MEMORANDUM

TO: El Paso County
FROM: Element Engineering
DATE: October 13, 2022
SUBJECT: Town of Ramah Wastewater System Improvements – Grading and Drainage Plan

Figure 1 - Proposed Lift Station Site

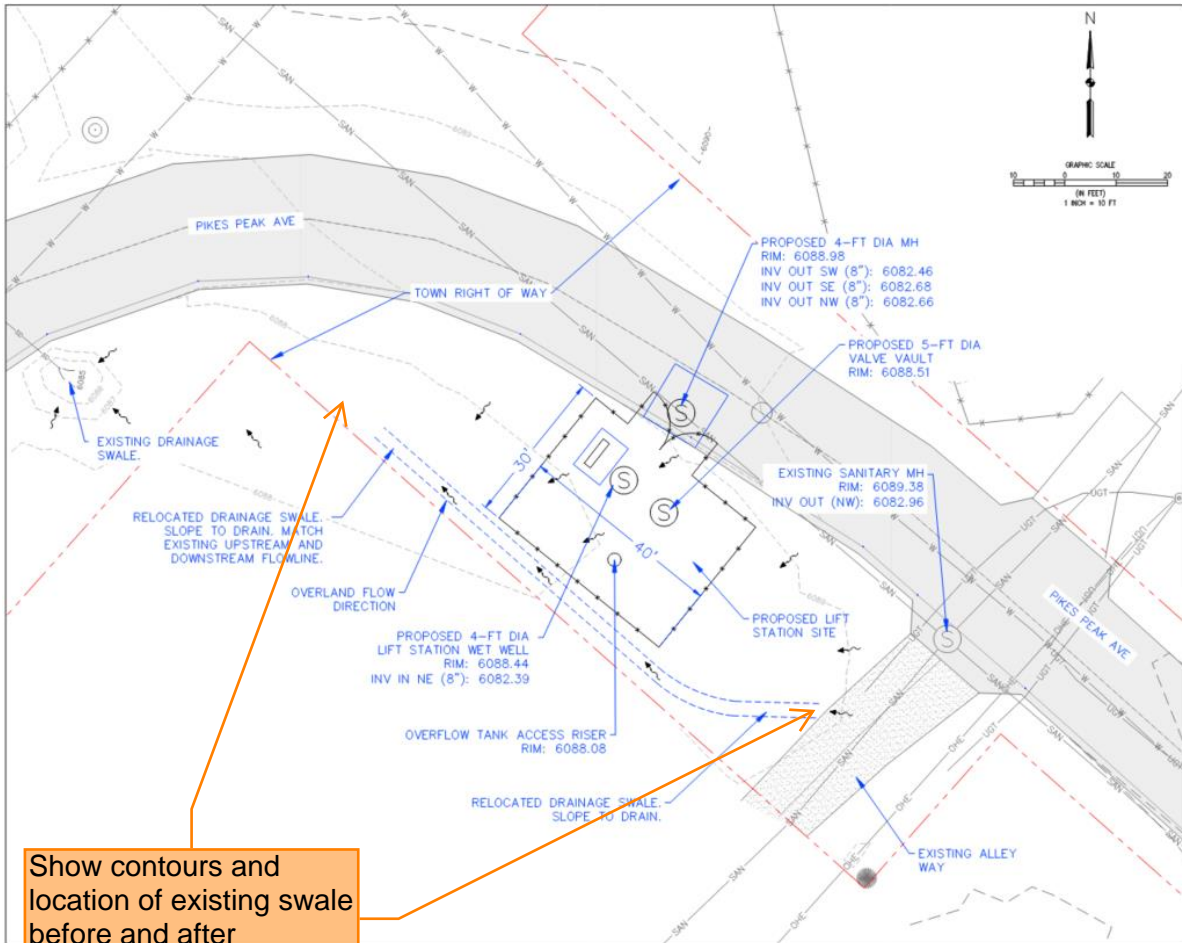
The site development plan shows a 34' x 9' concrete pad being installed. Please revise statement.

The CD's state that an existing drainage swale shall be relocated. Discuss the impacts as a result of that and document the proposed relocation. The slopes, size, and vegetation cover must be equivalent and sufficient to convey the runoff and not impact the lift station or road.

Determine minor and major flows which will reach proposed swale. Provide calculation to show design is able to adequately handle flow. Show if flow is same, more or less than existing flows releasing into existing wash area. If more, determine what impacts this has on the existing wash.

12687 W Cedar Drive, Suite 200, Lakewood, CO 80228, Elementengineering.n
Provide drainage basins and calculations for existing/proposed flows.

Show contours and location of existing swale before and after proposed relocation

Please include dimension.

Figure 2 – Proposed Evaporation Ponds Site

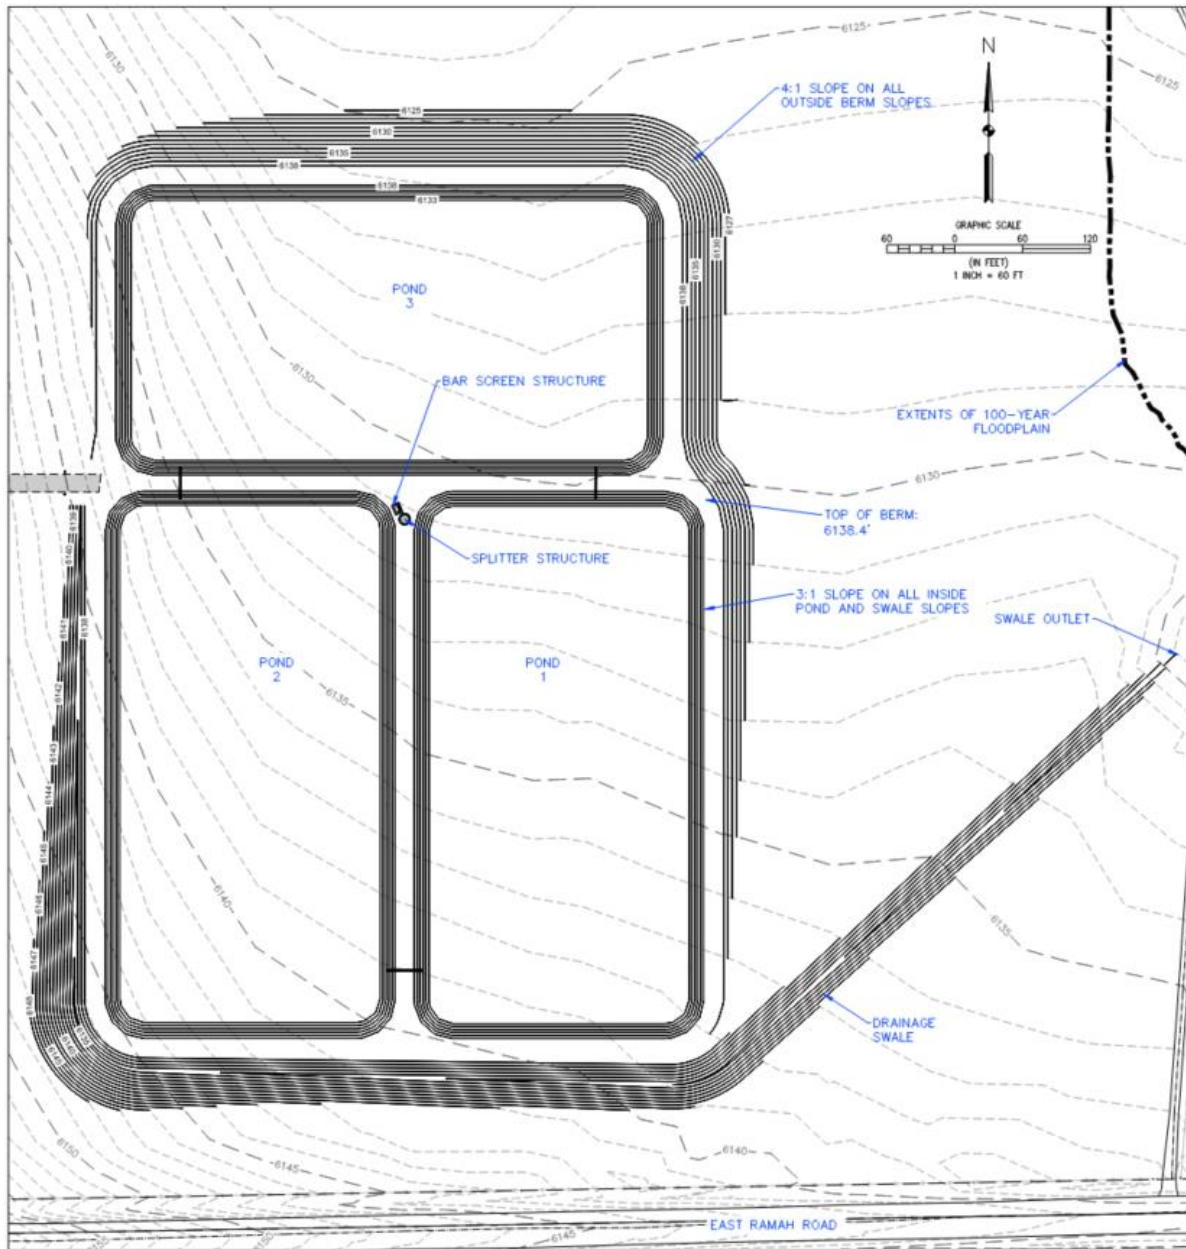
Cut and fill quantities do not match with what is shown on the CD set. Please verify quantities and update accordingly.

Figure 3 – Pond Drainage Swale

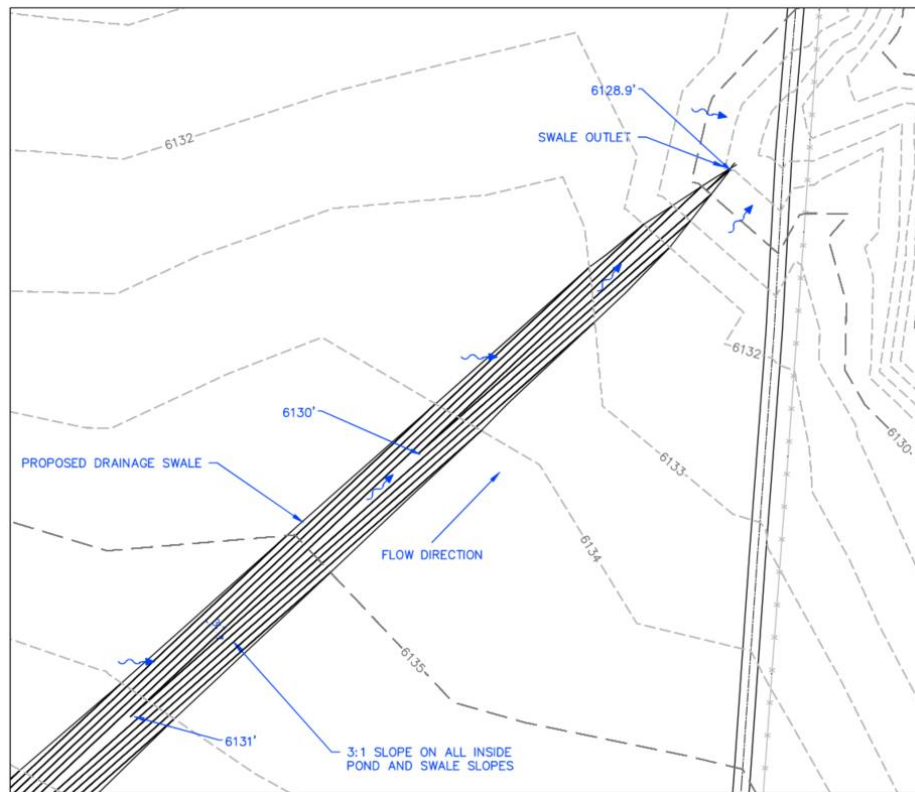
Per the comments on page 1 - the ditch design needs to be analyzed. Verify velocities are acceptable or provide erosion protection for ditch if necessary.

Provide the range of depths if the ditch size varies
